**ADDENDUM NO. 3**

Date: August 21, 2023

**Project: Project #: 0146-465  
0146-465 Isador Cohen ES / Rosemont HS Security Improvements: Group 1**

**C4.2**

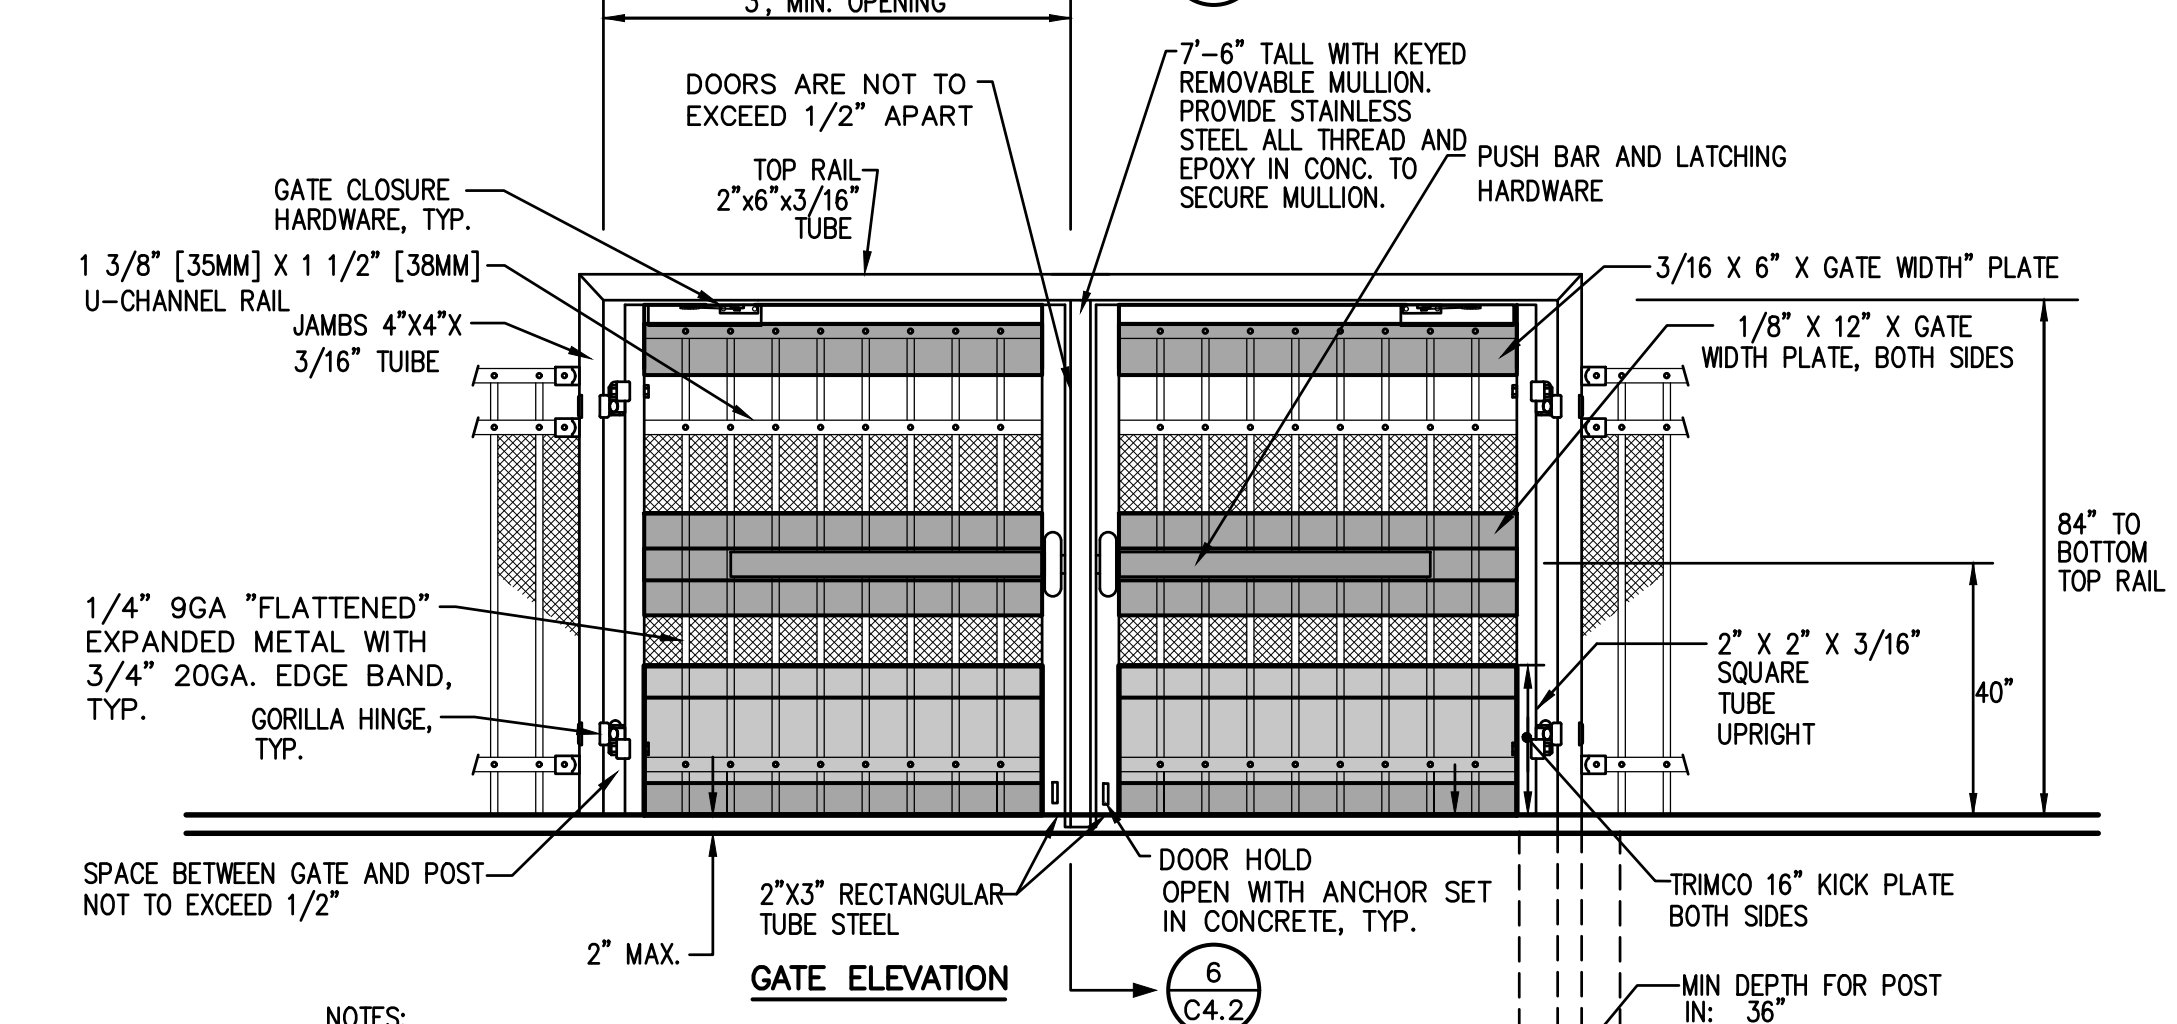
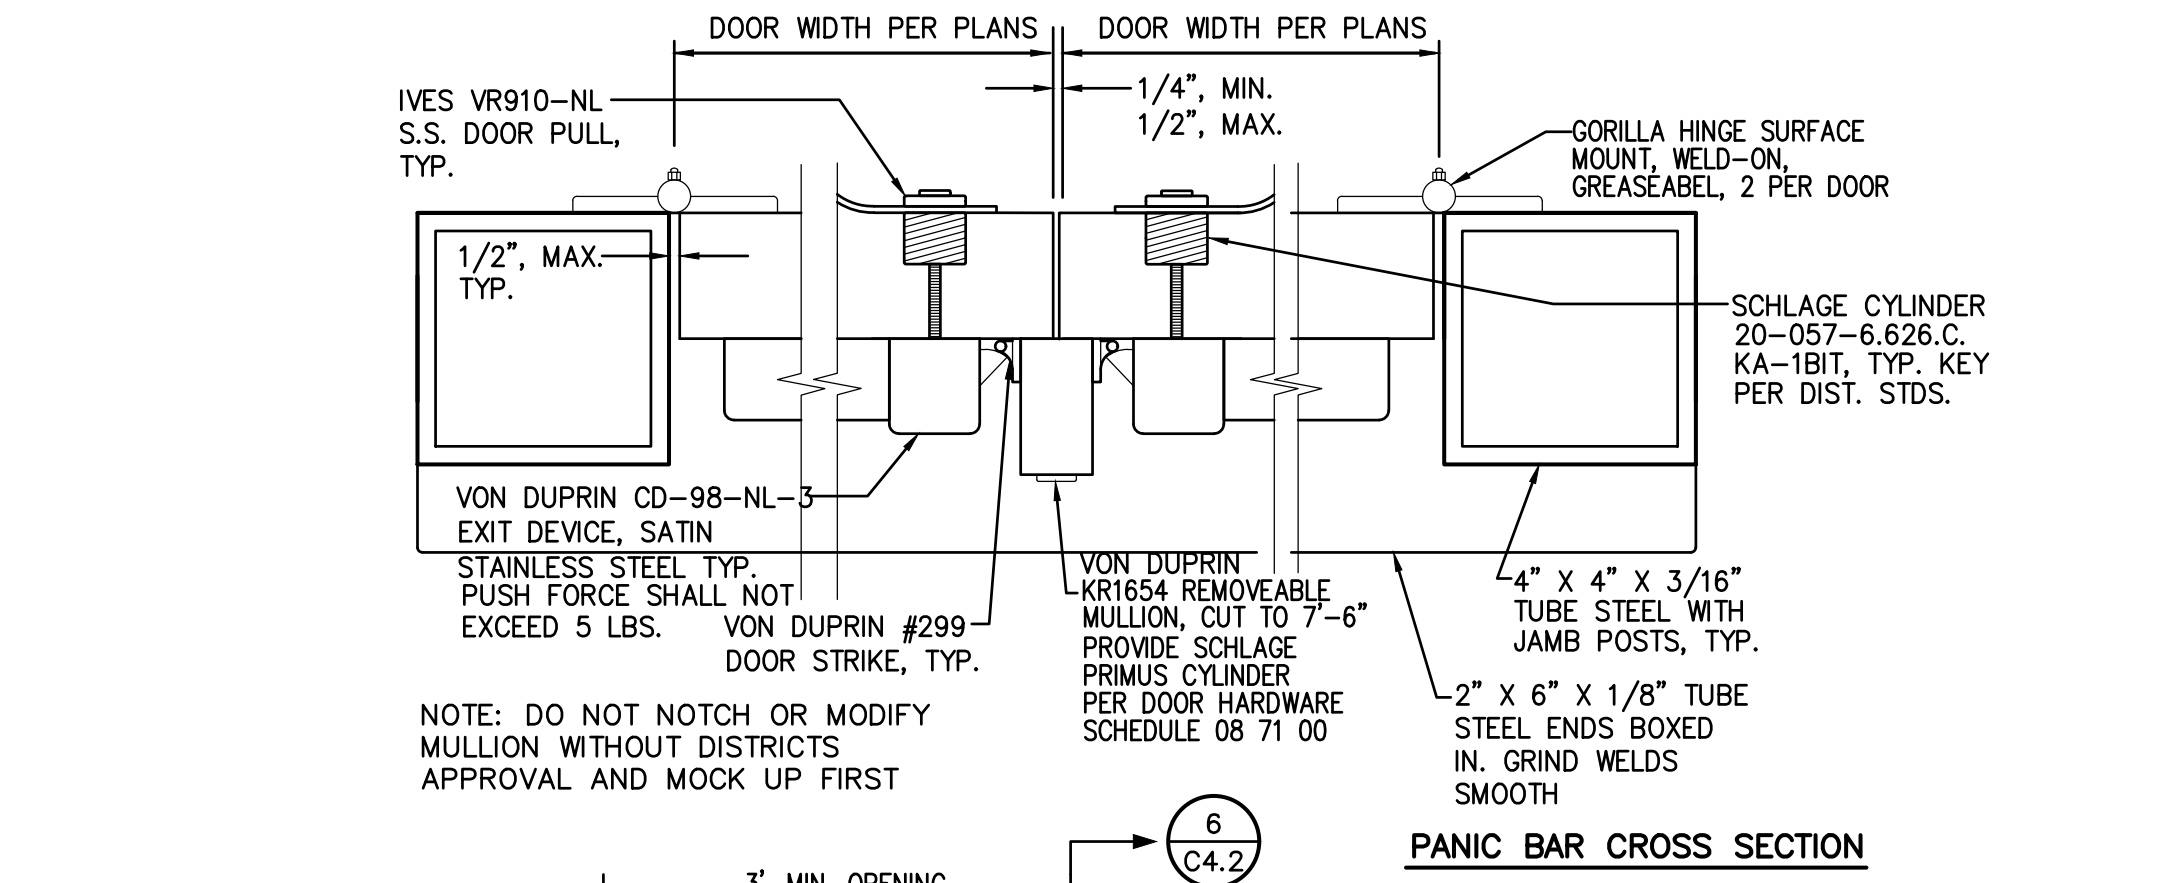
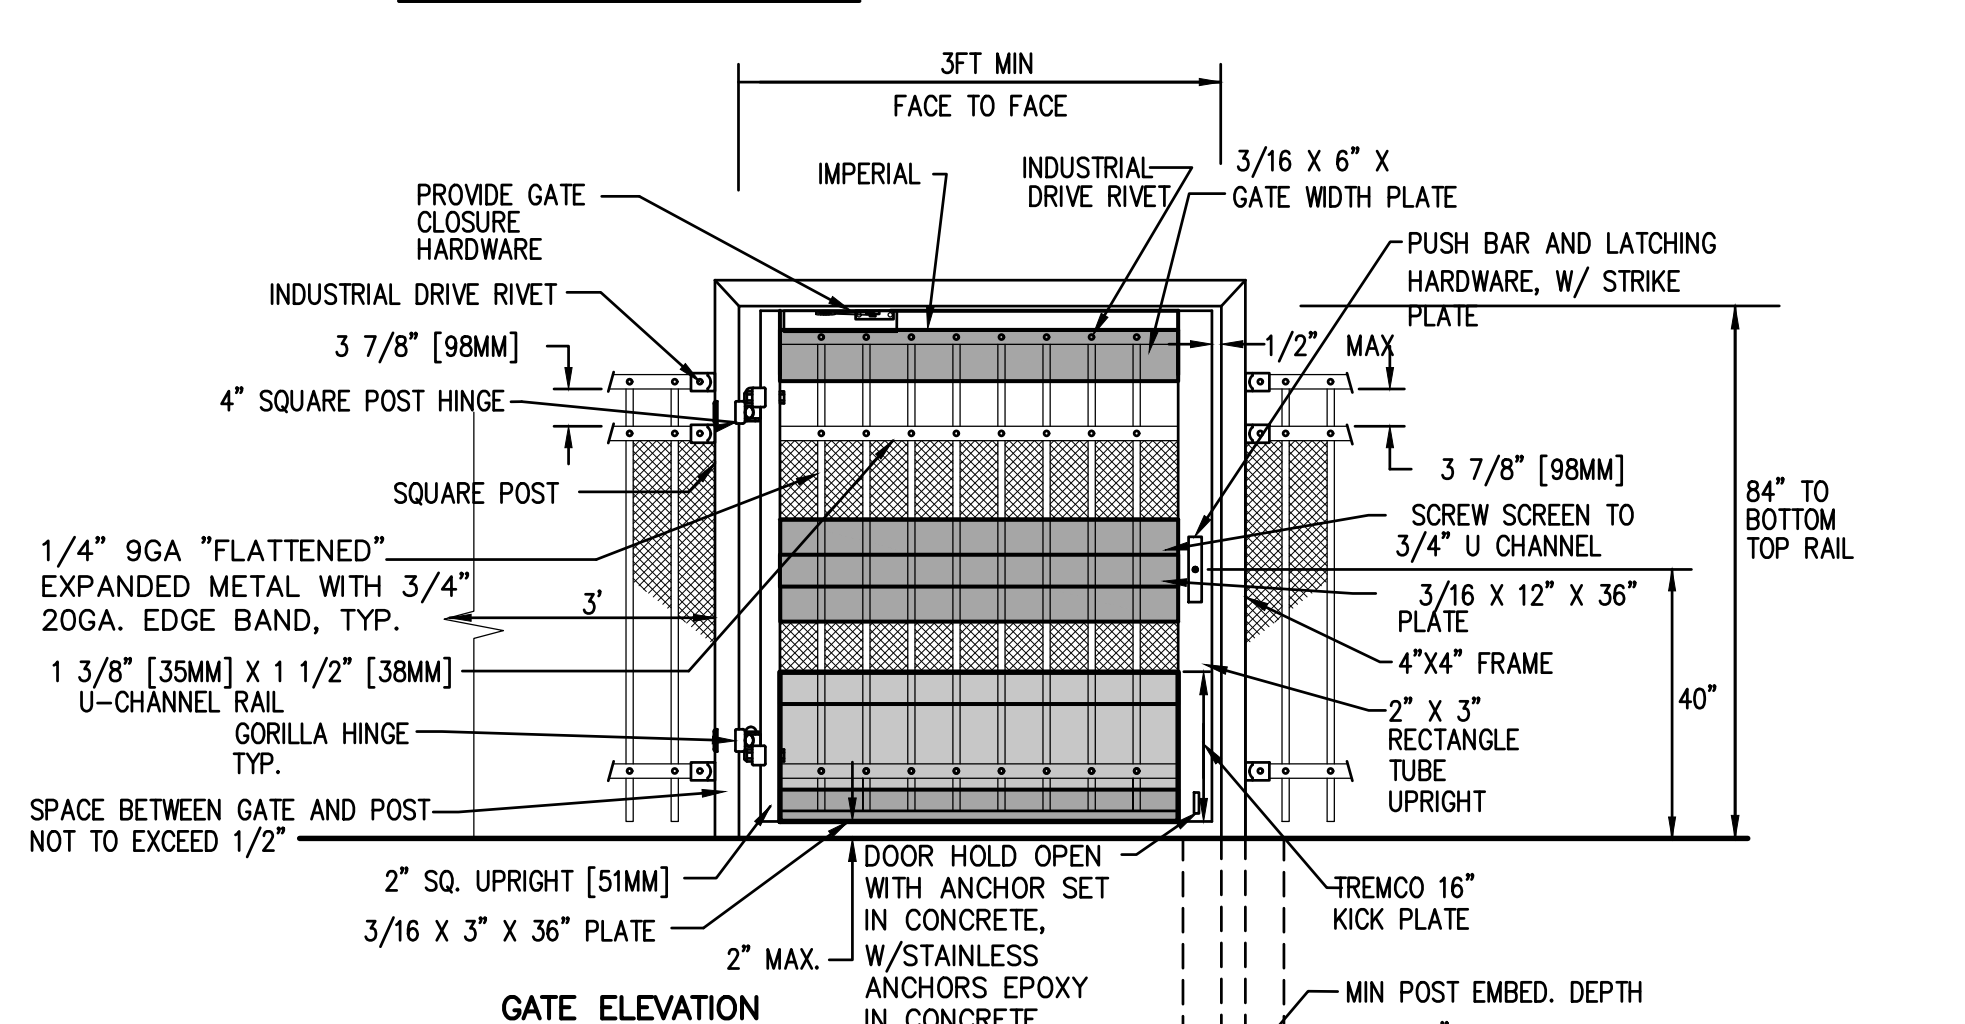
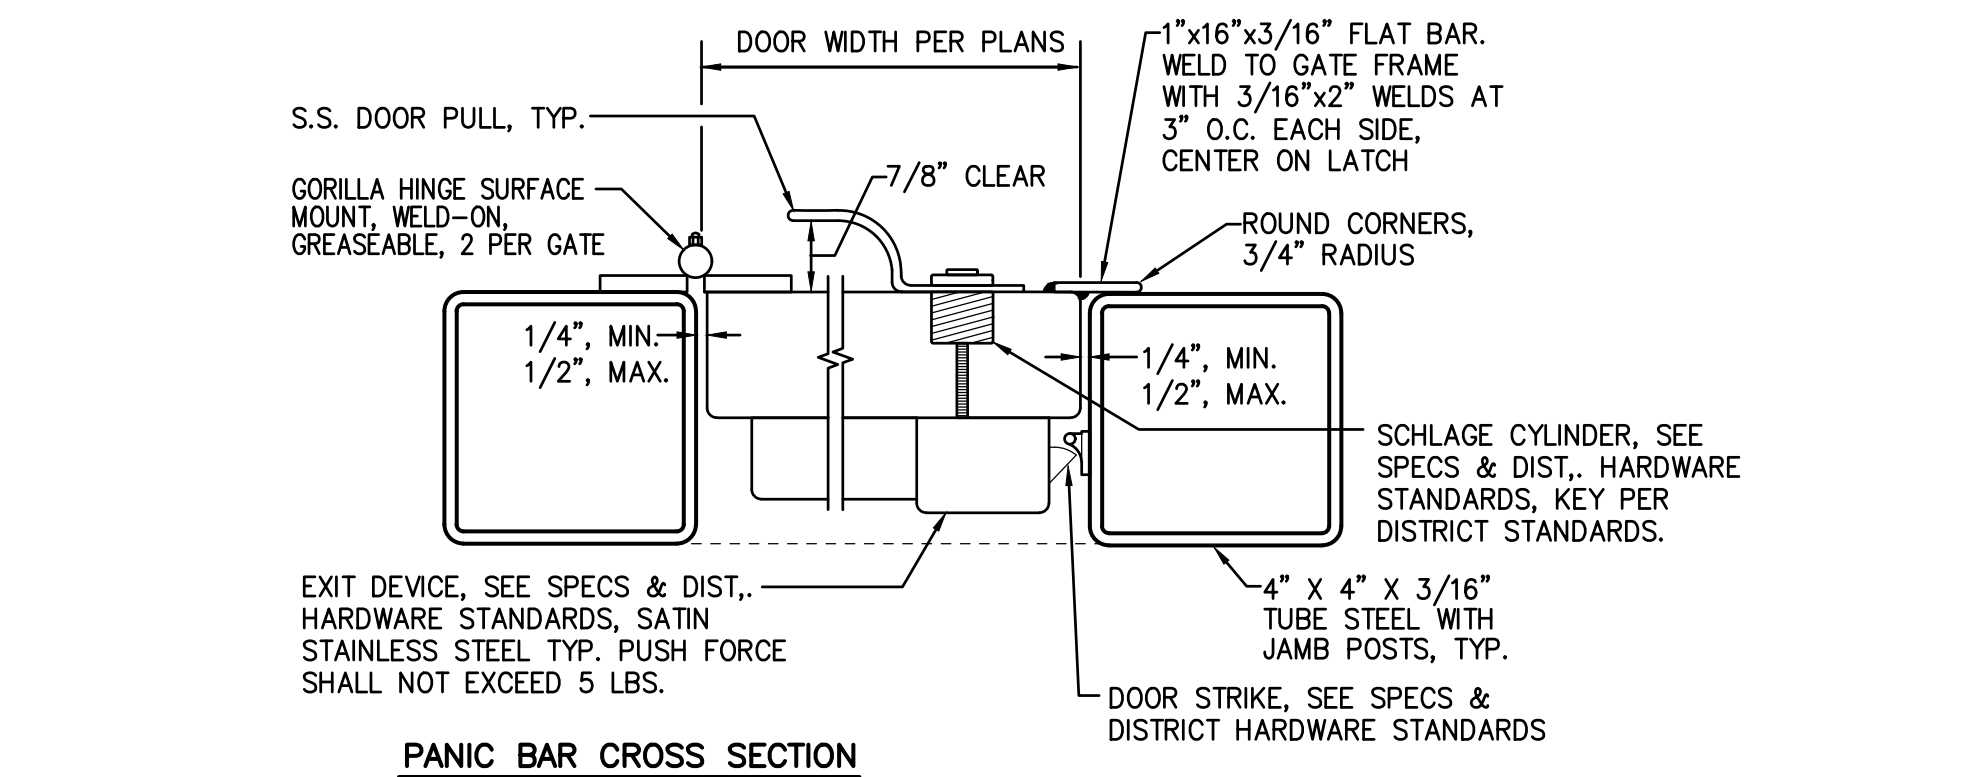
**Sheet C4.2**

- Detail 4 modified and detail 5 and 6 added.
